RE: DA2024/1216 – North Harbour Marina

NORTH HARBOUR MARINA – DA CONCERNS

Development Application Number: DA2024/1216

This is a supplementary submission to my original submission dated 16/10/2024.

Drawing No.: 6318-01/L

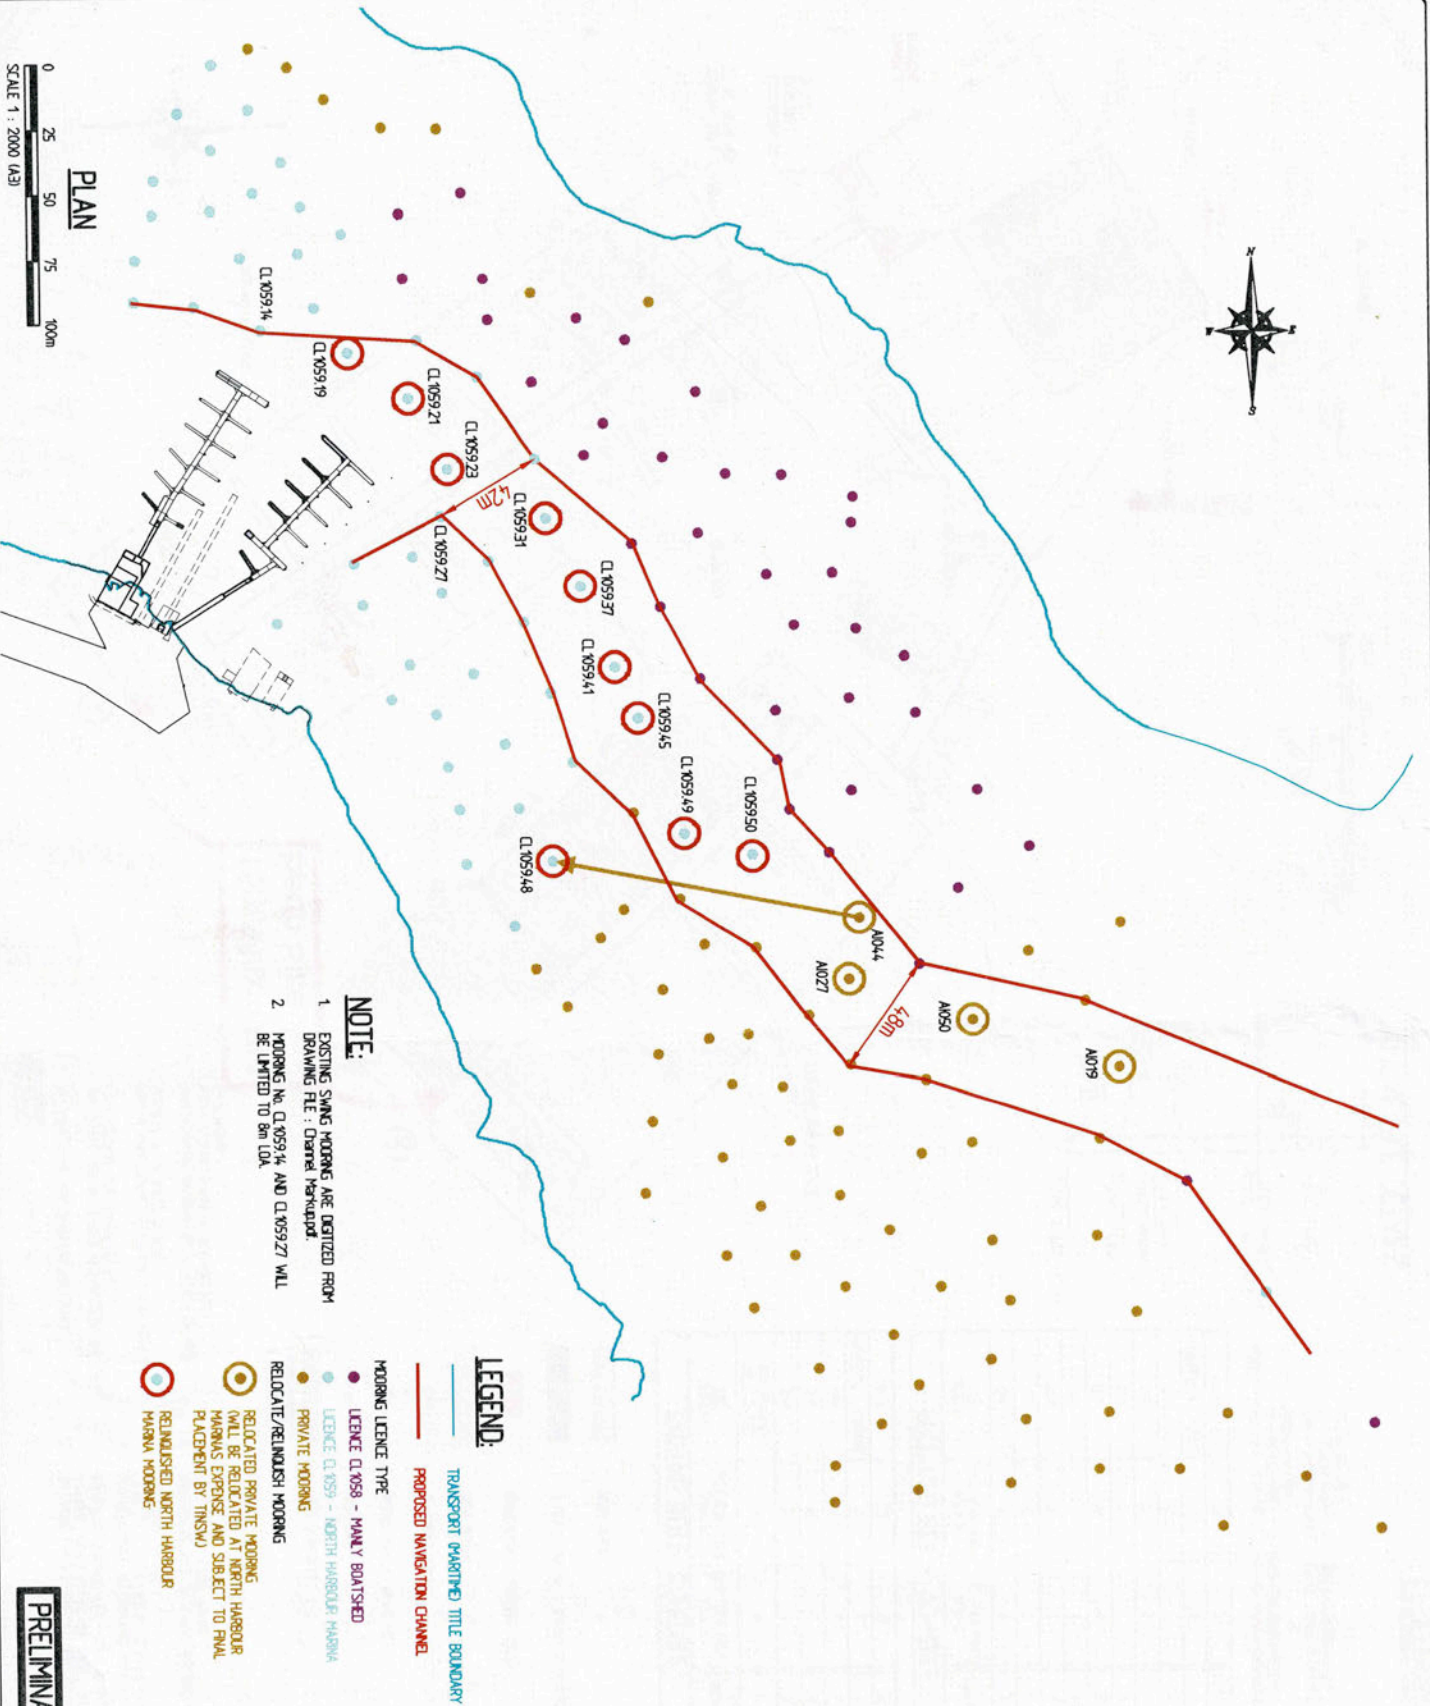
- There are two new 10m and 12m berths proposed on the eastern arm much closer to the existing beach.
- There is insufficient depth of water (1m) without dredging which would increase beach erosion and decrease the use of small craft from the beach to the east between NHM and North Harbour Sailing Club.
- Furthermore, the 10m berth shown on the eastern side of the Eastern arm closest to the shoreline is outside of the applicants lease area.

- The applicant has indicated a maximum vessel size of 15m - if imposed by Council.
- It is in fact continuing to provide space for 32m and 25m superyachts on both T-Heads of the Eastern and Western arms.

- The applicant has indicated in the draft fall back plan that there will be a 15m vessel size limit on the ends of both the Eastern and Western T-Heads (per attached – red arrows).
- Under the original plan as submitted, there is only 1 x 15m vessel in the marina.
- It now appears that the applicant wants 4 x 15m vessels, 2 x 15m vessels on the ends of each arm.
- Council should prohibit more than 1 x 15m vessel in the marina as per the original submitted plans

- A simple inspection of Google earth indicates that the distance between the Eastern and Western arms is exaggerated on the plan.
- The true distance between the arms offers insufficient space for safe berthing.

- It is not compliant with the Australian Standard (AS 3962) regarding Marinas, Channels and Fairways.

- As far as I am aware the existing pump out facility on the western arm has not been operative.
- No pump out is proposed for the Eastern arm. The danger of vessels discharging sewerage must be greatly increased by the absence of pump-out facilities and the channel invites more and larger vessels into North Harbour.
- Moreover, even if the existing pump out was operative, the proposed 12m permanent berth would preclude general usage for all marina customers. The environmental threat is obvious.
